**RAND PROJECT**  
**RANDBURG, KERN COUNTY,**  
**CALIFORNIA**

**FINAL**  
**ENVIRONMENTAL IMPACT STATEMENT/**  
**ENVIRONMENTAL IMPACT REPORT**

State Clearinghouse Number 93042054

APRIL 1995

Figure 2-14: Cross Section of a Typical End-Dump Waste Rock Stockpile, Rand Project

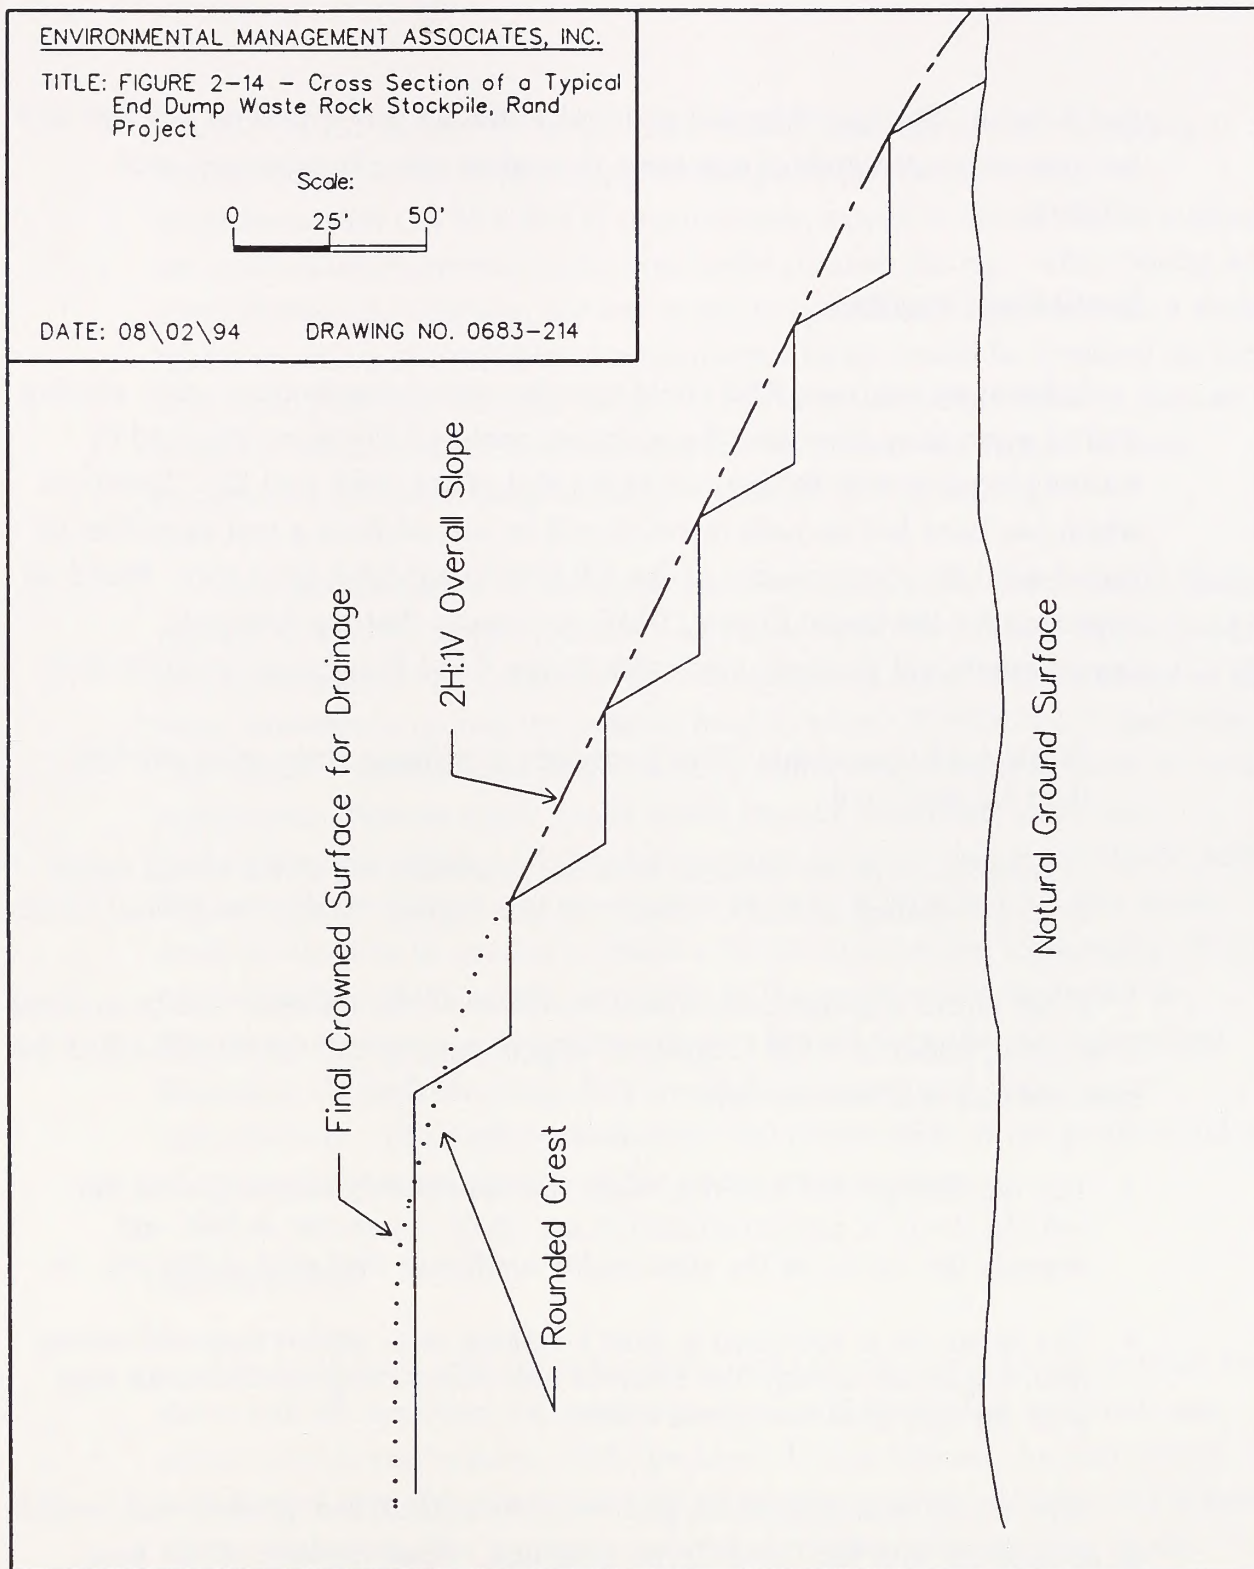
- 9-2 | The reclamation plan indicates that the final waste rock fill slopes will be approximately 350 feet high. Figure 2-14 of the reclamation plan indicates that the final slopes for the waste rock stockpiles will have an overall slope of 2H:1V with bench slopes of approximately 1/2H:1V

RESPONSES TO COMMENTS	
Comment No.	Response
RESOURCES	
<u>Physiography and Geology</u>	
5-2	The scale shown on Figure 4-3 is accurate.
9-1	Mine pit walls have been designed to provide safety to workers while allowing maximum economic extraction of the resource. Some sloughing of pit walls is likely to occur after cessation of mining; however, these materials would be contained within the pit. RMC will maintain pit wall stability consistent with applicable MSHA requirements.
9-2	As indicated in Response to Comment No. 13-2, the waste rock stockpile slopes will be at an overall 2H:1V slope. Some sloughing of the waste rock stockpile bench faces would gradually occur. However, RMC's geotechnical analysis of waste rock stockpiles indicates that the benches below these slopes, and the stockpile's overall 2H:1V slopes, would prevent any significant amount of material instability. Once the bench faces sloughed, they would eventually approach the overall 2H:1V gradient.

TITLE: FIGURE 4-5 - Water Walls in Northeastern  
Fremont Valley

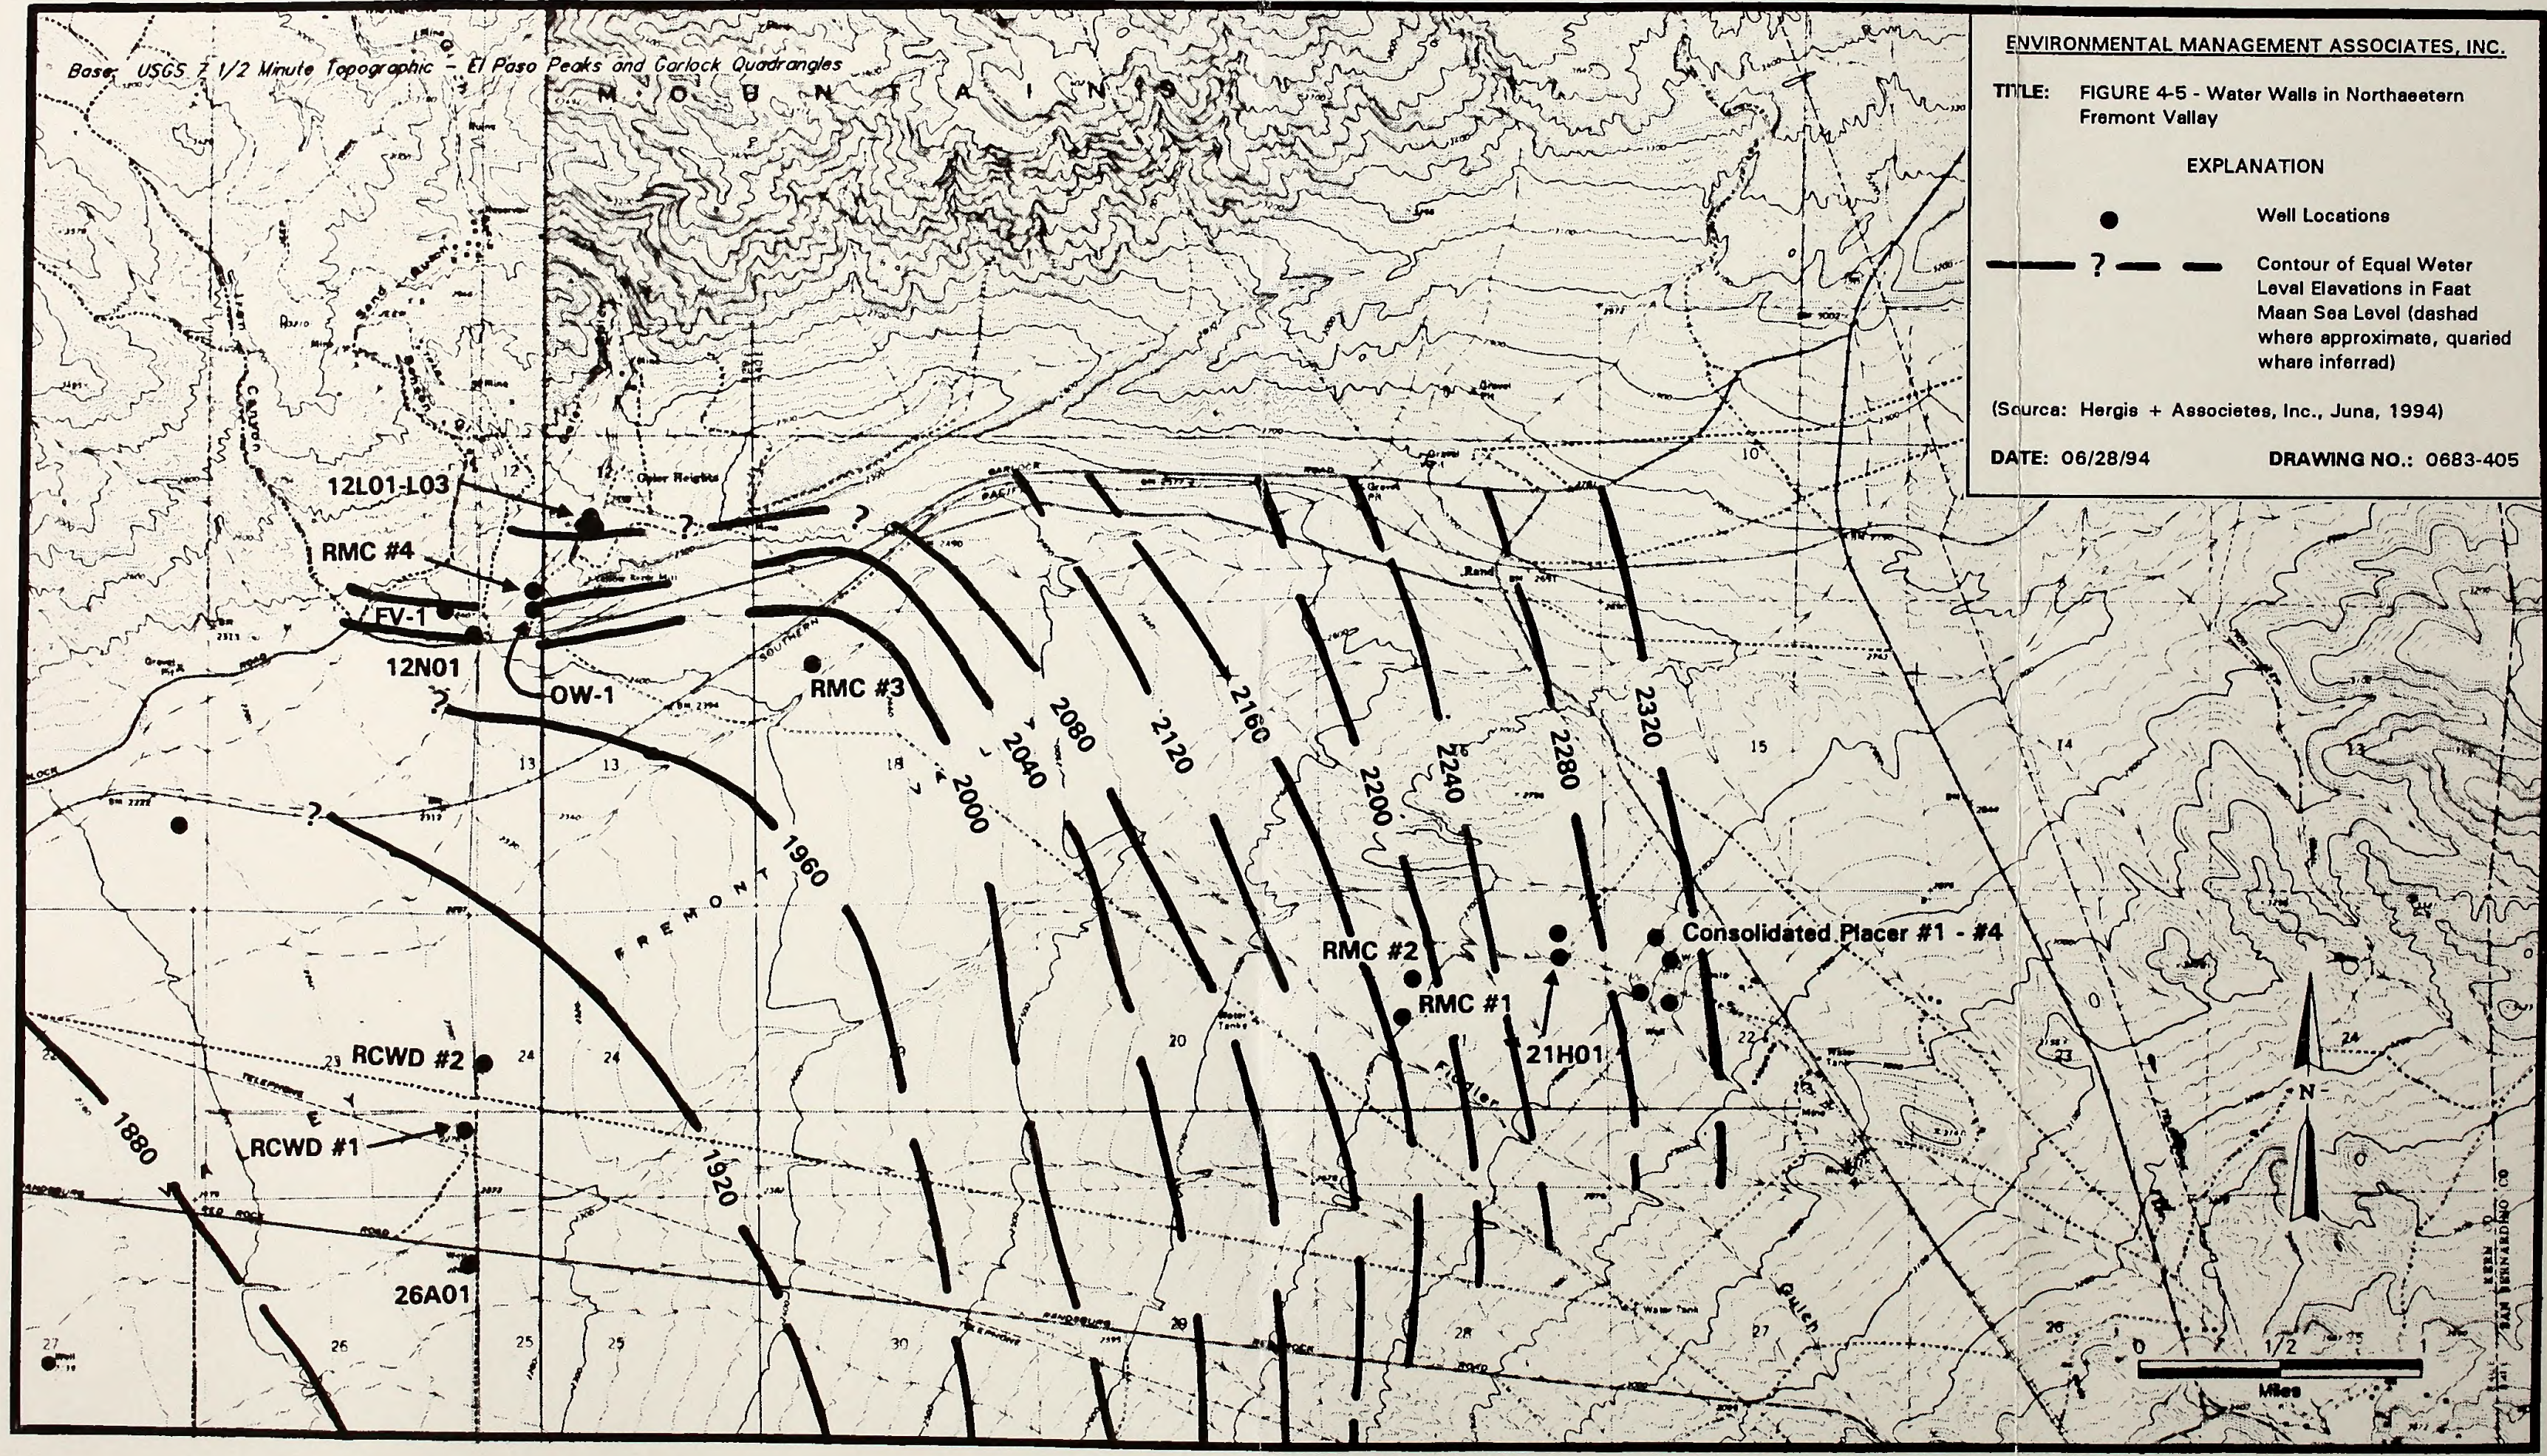
Page 4-11, Sec. 4.4.2, Page 4-12, Fig. 4-5, Page 5-6, Sec. 5.1.4.2 and Page 5-7, Fig. 5-1 -- Groundwater. The figure does not include the location of the Garlock Fault. Is the fault on the edge of the basin as defined for groundwater modeling? If not, does the fault run somewhere through the basin? If this is true, how can the contour of equal water level be such nice curves? Would not the fault offset the sediments, thereby causing different water levels on either side of the fault? Lack of this information causes serious doubts as to the accuracy of the groundwater modeling. If the model has not taken the fault into account, then either an explanation of why the fault does not affect the model, or a groundwater model that does take it into account, must be done.
